## **Town of Arlington, MA Redevelopment Board**

### **Agenda & Meeting Notice October 21, 2024**

#### **3. Public Hearing: Docket #3798, 821 Massachusetts Ave (continued from July 1, 2024)**

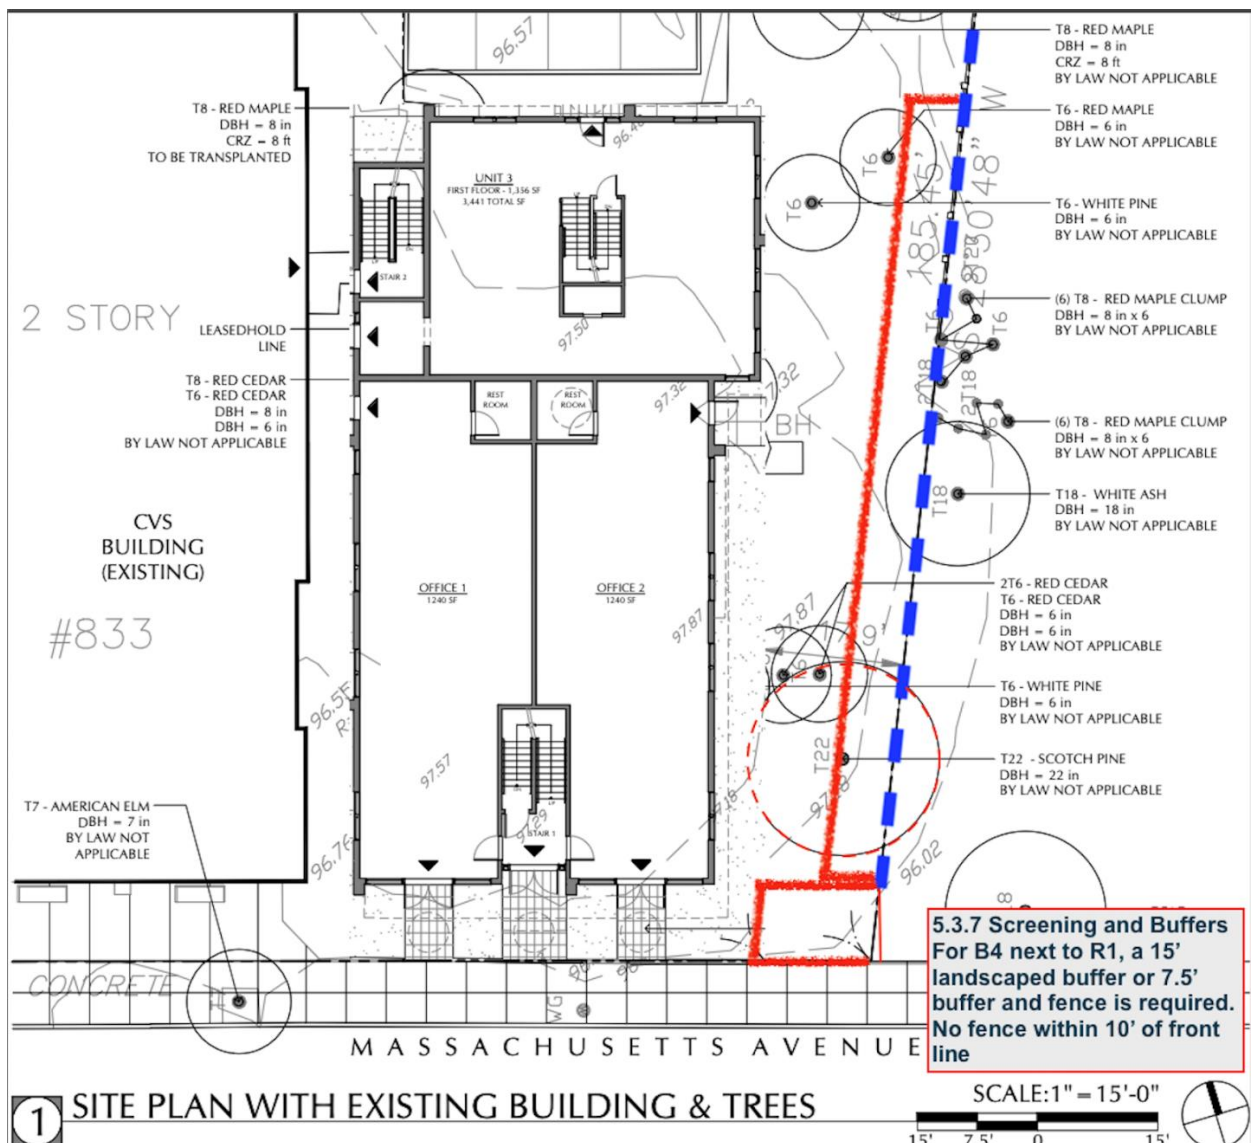
3. legality of the current Plan:

Not only shifting the building closer to CVS would protect the tree - it would also **satisfy requirements of the article 5.3.7 of the zoning bylaw**

<https://www.arlingtonma.gov/home/showpublisheddocument/43413/638500759460700000> - that
